CITY OF KELOWNA

MEMORANDUM

Date: September 15, 2020
File No.: Z20-0081
To: Urban Planning Management (KB)
From: Development Engineering Manager (JK)
Subject: 605 Gerstmar Rd RU1 to RU2

**SKETCH PLAN OF PROPOSED SUBDIVISION OF LOT 5
 SECTION 22 TOWNSHIP 26 OSOYOOS DIVISION YALE DISTRICT PLAN 19913**

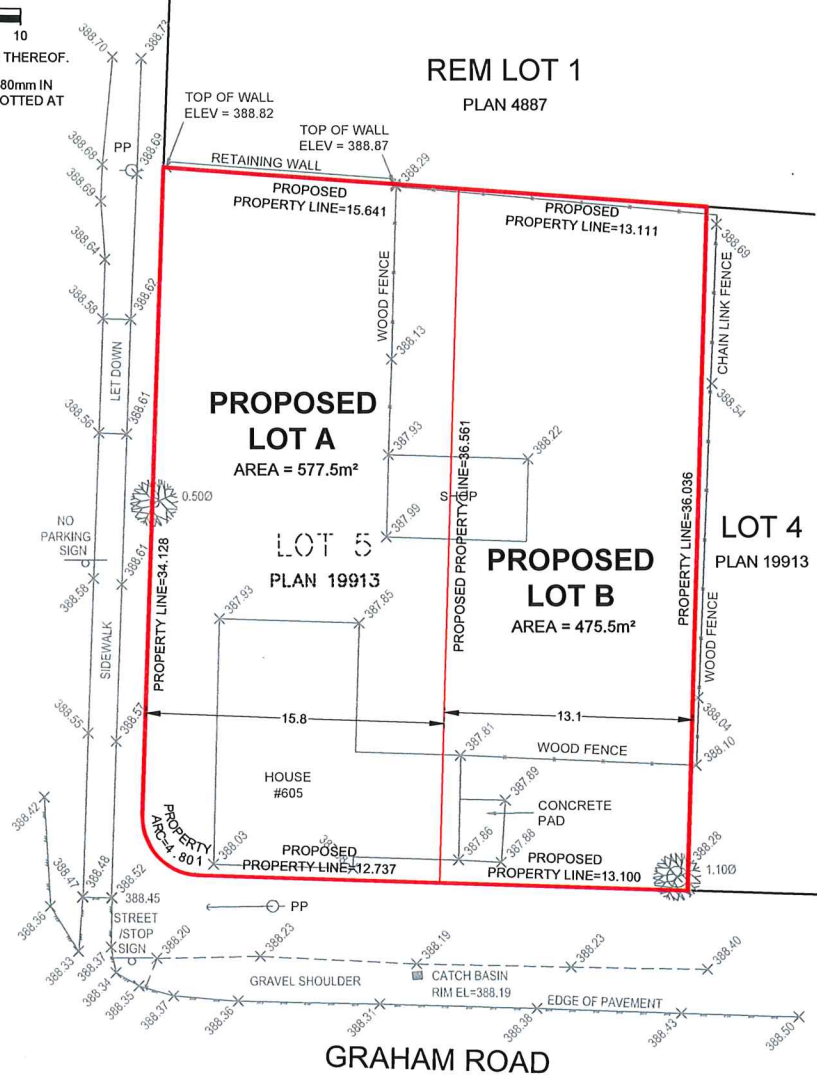
The Development Engineering Department has the following comments and requirements associated with this application to rezone the subject property from RU1 (Large-lot housing) to RU2 (Medium-lot housing) to support a two-lot subdivision. The road and utility upgrading requirements outlined in this report will be a requirement of this development. The Development Engineering Technician for this project is Sarah Kelly.

- a) Each legal lot shall require only one individual sanitary service connection complete with an inspection chamber (SS-S7) and Brooks Box (SS-S9), to be installed at the applicant's cost.
- b) The existing lot is currently serviced with a 100-mm sanitary service. If the existing service connection is to remain it will be required to be completed with an inspection chamber and Brooks box.

- a) Gerstmar Rd is classified as a Major Collector under the City of Kelowna's 20-Year Major Road Network. The section of Gerstmar Rd must be upgraded to a collector standard along the full frontage of this proposed development, including sidewalk, curb and gutter, pavement removal and replacement, boulevard landscaping, drainage infrastructure (catch basins, perforated storm pipe, and drywell), and re-location or adjustment of utility appurtenances if required to accommodate the upgrading construction. The road cross section to be used is SS-R6.
NOTE: Pipe and drywell inverts to consider eventual connection to existing storm main at Gerstmar Rd and Tataryn Rd – DWG A-2482-4.

- c) Graham Rd must be upgraded to a local standard along the full frontage of this proposed development including curb and gutter, pavement removal and replacement, boulevard landscaping and re-location or adjustment of utility appurtenances if required to accommodate the upgrading construction. The existing catch basin is to be relocated to the new gutter line. The road cross section to be used is a modified SS-R3.
